**Bastrop County Precinct 2 Road and Bridge Facility Construction**

**RFB 25BCP04J**

**ADDENDUM #2**

Addendum #2 provides clarification and answers from questions submitted by contractors and has an updated drawing and specification package as some aspects of the project have changed. Bastrop County is extending the due date for submissions until June 4, 2025, at 2:00PM. The new deadline for questions concerning the scope of work is May 27, 2025, at 5:00PM. Below is a list of documents that are included in Addendum #2:

**2** WALL SECTION - BREAKROOM & WORKSHOP (TRUE WEST)  
1/2" = 1'-0"

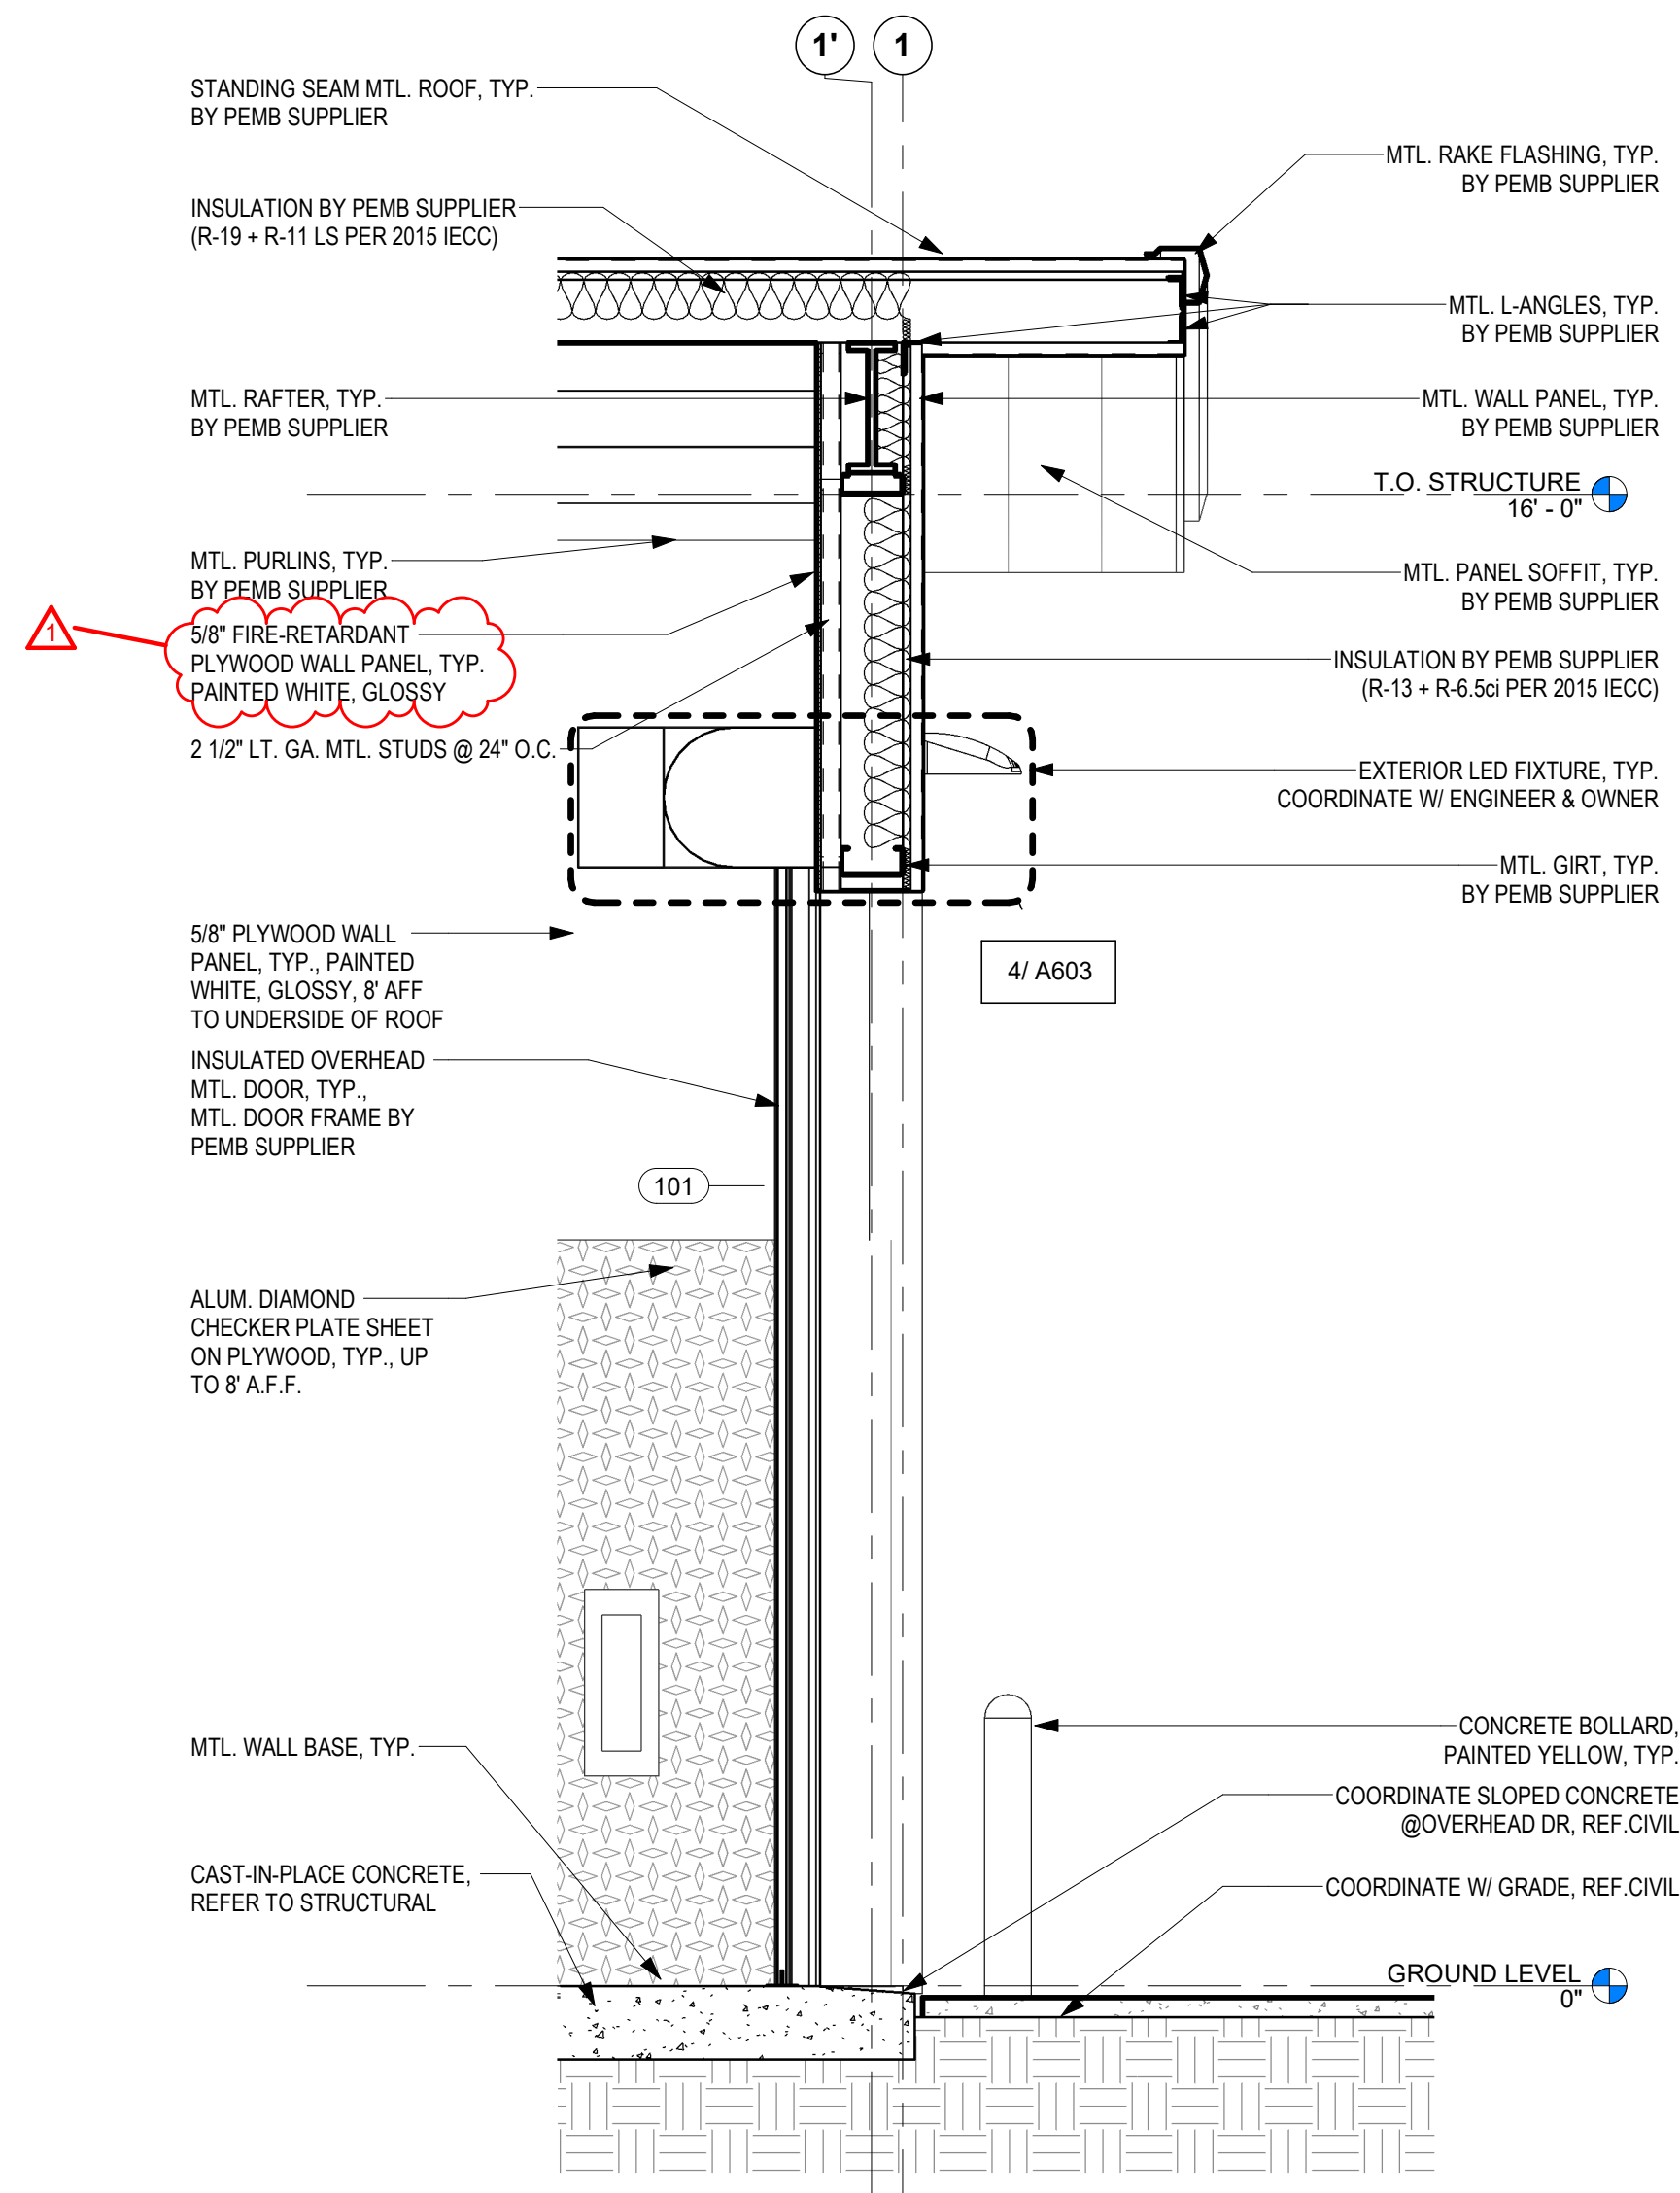
*4. Sheets A400, A401 - Details on these pages show 5/8 plywood as being installed on the walls. As this building is classified as a IIB building per the information provided on sheet A006. Provide documentation to show the use of 5/8 plywood exposed on the wall surfaces complies with Section 603.1*

CasaBella Architects Response: Refer to revised sheet A005, A400, 401, call out for fire-retardant plywood at exterior walls.
